Project Name: ANCHORAGE INN - ADDITION Map: 137 Lot: 35 Date: 1/9/2021

Ref: Anchorage Inn – 14 Wadleigh Road

The following updates are made to this revised set:

ANCHORAGE INN
14 WADLEIGH
ROCHESTER NH

EXISTING SITE,
LANDSCAPE & LIGHTING

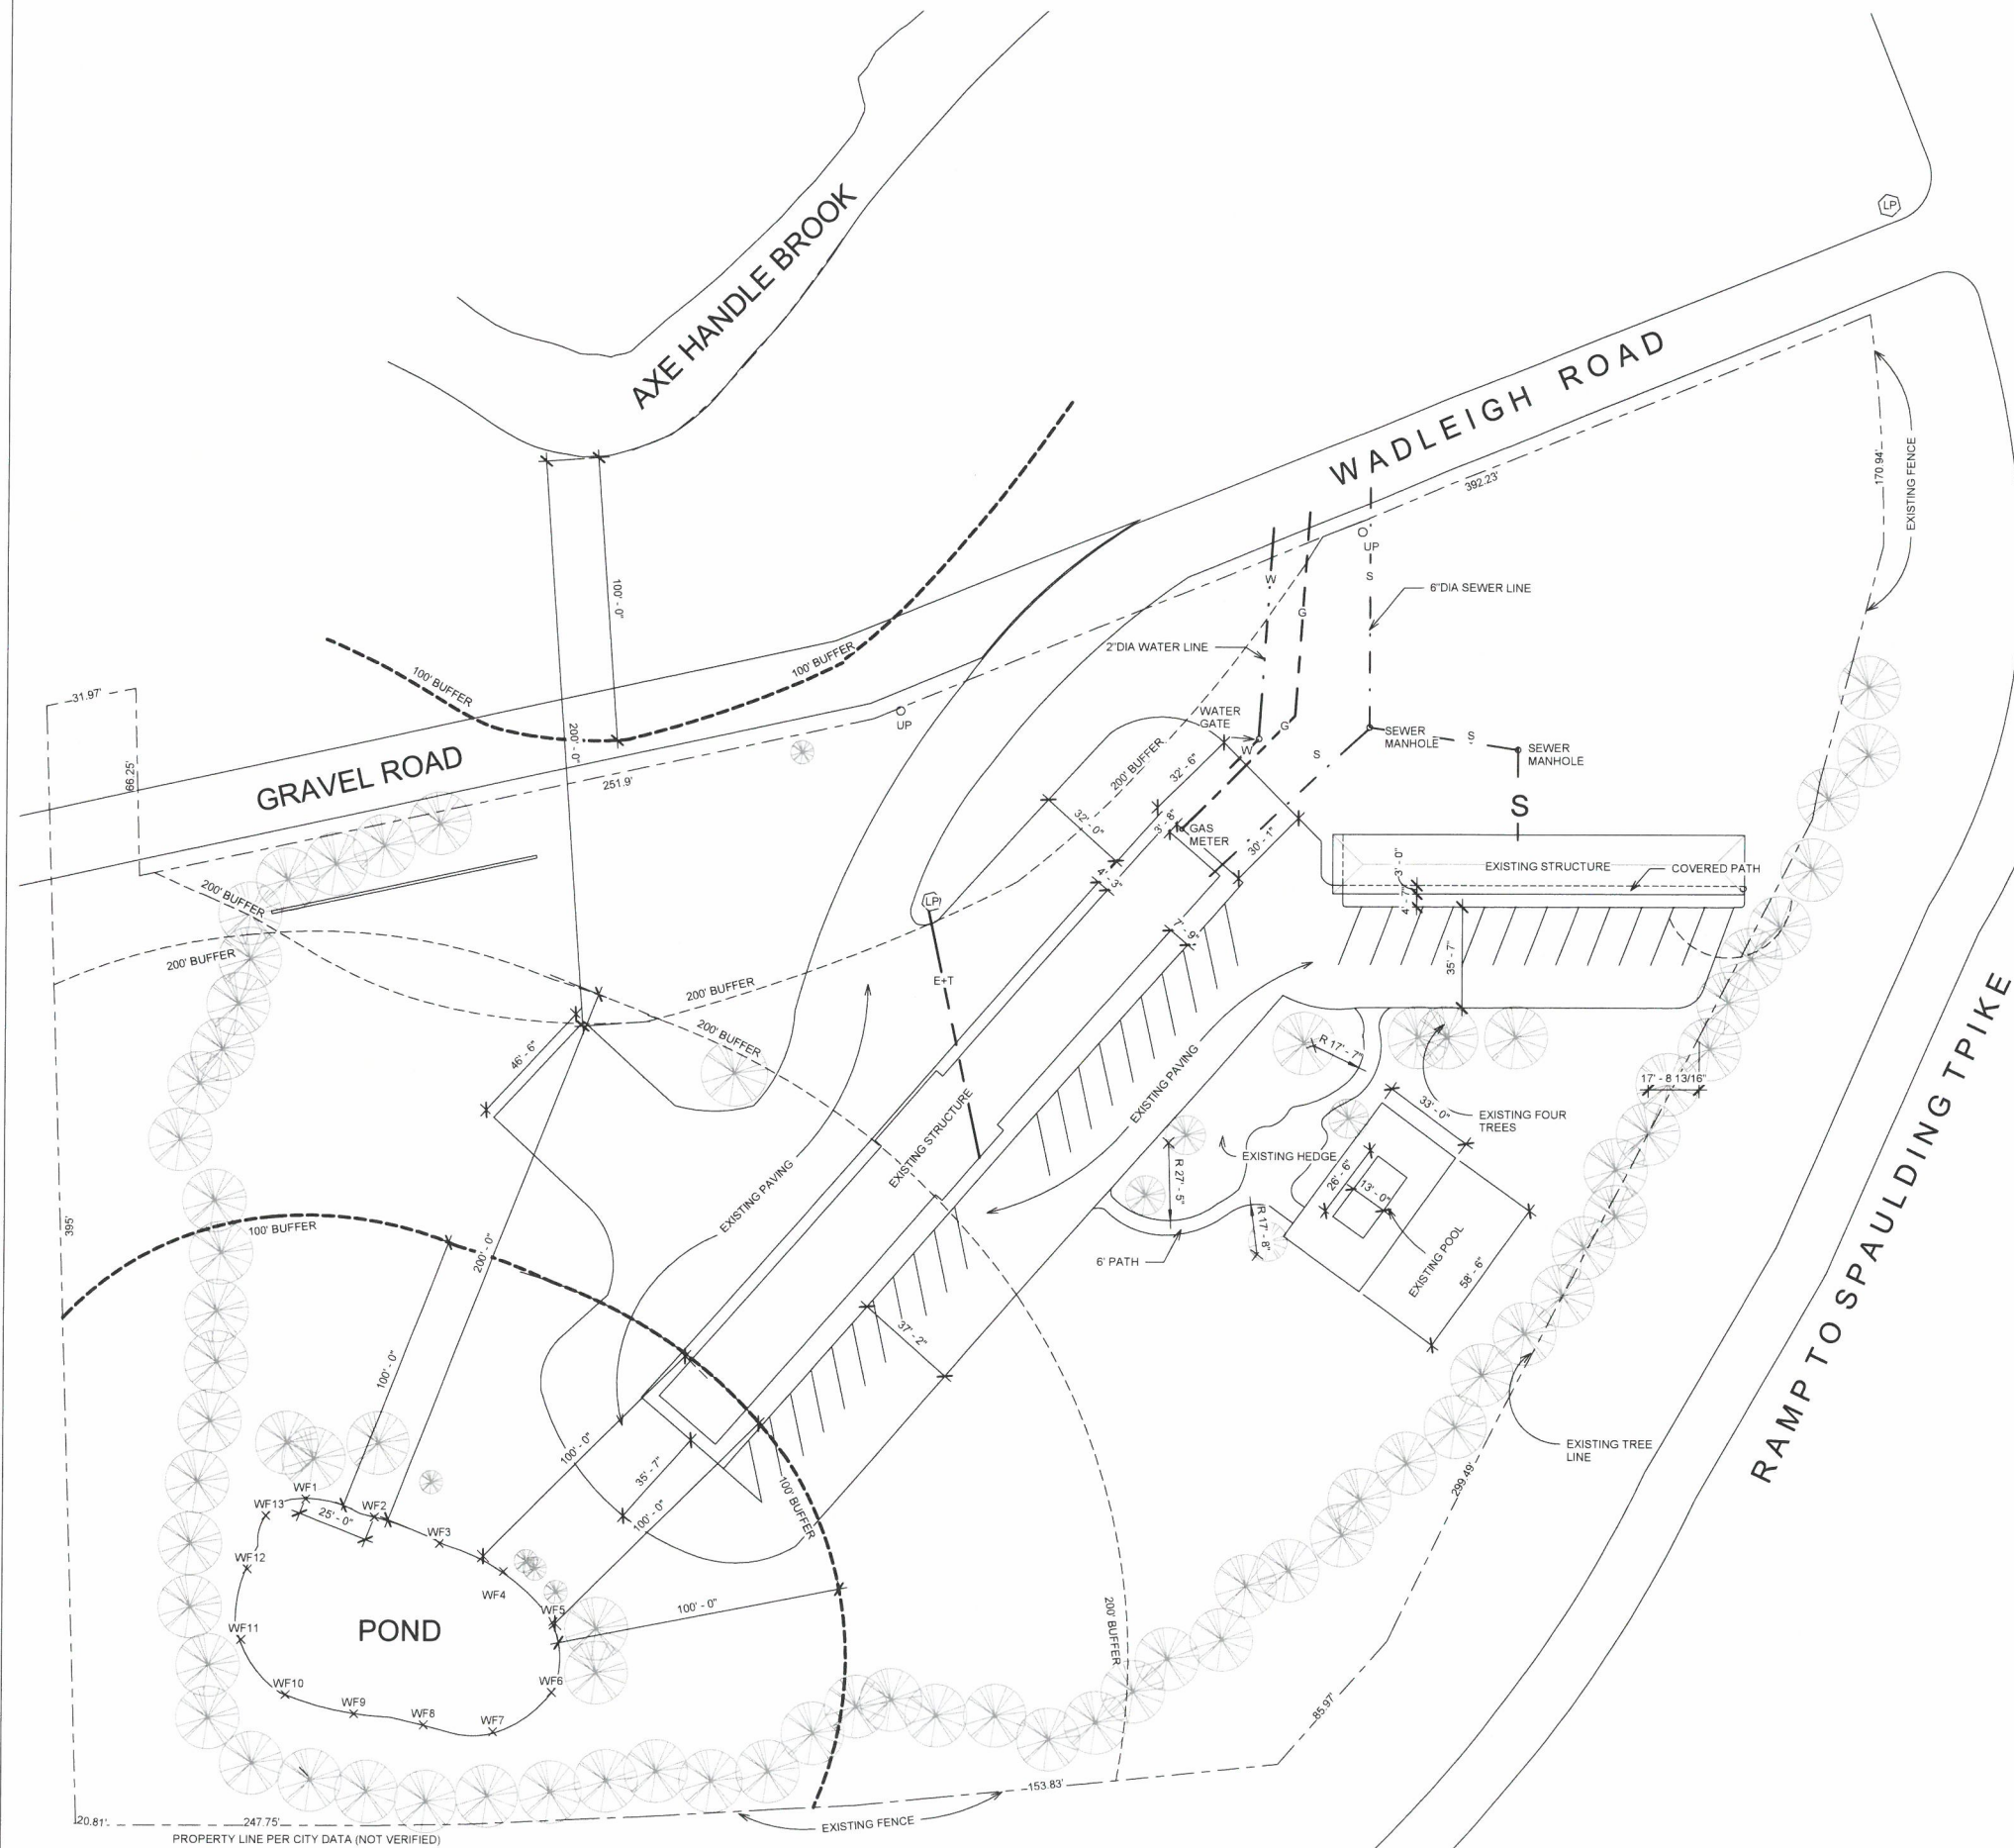
- a) Existing Conditions Plan showing widths of paved areas, walkways patio's etc. have been added to the EX sheet showing existing conditions, existing Landscape and existing Site Lights.

- d) Utility plan showing location of utilities and size of water, sewer and drainage pipes – These items are shown on the EX sheet as all these are existing and no new services / utilities are proposed in this phase I. Existing water, sewer and gas lines are adequate.
